Access Compliance Report

Public Rights-of-Way

Intersection ID: 9651	Main Street: CRESTVIEW_DR	Cross Street: FRENCH_ST	Location: NW
ADA ID: BF7C97F9FD42	Ramp Type: PerpDiag	Initial Pass/Fail: Fail	Overall Compliance: No
		Severity Score: 25

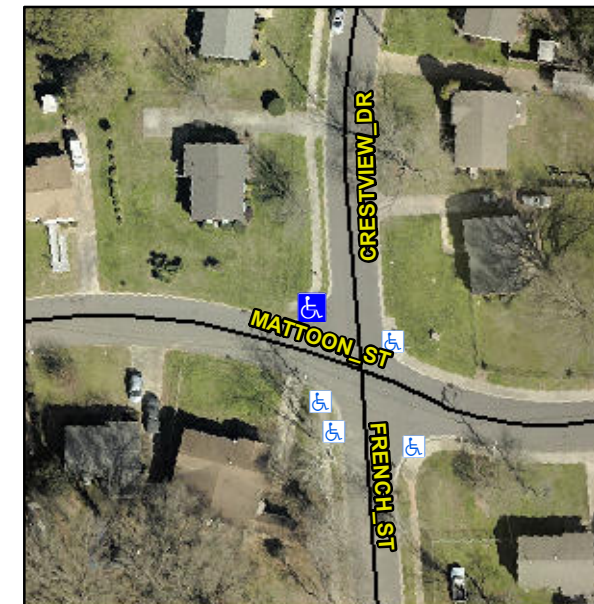
Not Found, R304.5.3

Compliance	Description	Data	Compliance	Description	Data
N/A	Ramp Length (in)	49.0	Yes	Ramp Slope (%)	5.0
Yes	Ramp Width (in)	48.0	No	Ramp XSlope (%)	7.7
N/A	Flare Type LT	N/A	N/A	Flare Type RT	N/A
N/A	Flare Slope LT (%)	N/A	N/A	Flare Slope RT (%)	N/A
N/A	Flare Traversable LT?	N/A	N/A	Flare Traversable RT?	N/A
N/A	Landing Length (in)	N/A	N/A	DWS Provided?	N/A
N/A	Landing Width (in)	N/A	N/A	DWS Contrast?	N/A
N/A	Landing Slope (%)	N/A	N/A	DWS Length (in)	N/A
N/A	Landing X Slope (%)	N/A	N/A	DWS Full Width?	N/A
N/A	Landing Curb? (Y/N)	N/A	N/A	DWS Offset (in)	N/A
N/A	Shared Landing?	N/A			
N/A	Gutter Ponding?	N/A	N/A	Gutter Slope (%)	N/A
N/A	Gutter Lip Ht (in)	0.5	N/A	Gutter X Slope (%)	N/A
N/A	Painted X Walk1?	No	N/A	Painted X Walk2?	No
	X Walk 1 Direction	To S		X Walk 2 Direction	To E
N/A	X Walk 1 Width (in)	N/A	N/A	X Walk 2 Width (in)	N/A
	X Walk 1 Slope (%)	3.8		X Walk 2 Slope (%)	9.1
	X Walk 1 X Slope (%)	9.3		X Walk 2 X Slope (%)	0.5

Remove & Replace Curb Ramp With Two New Directional Ramps or Equivalent.
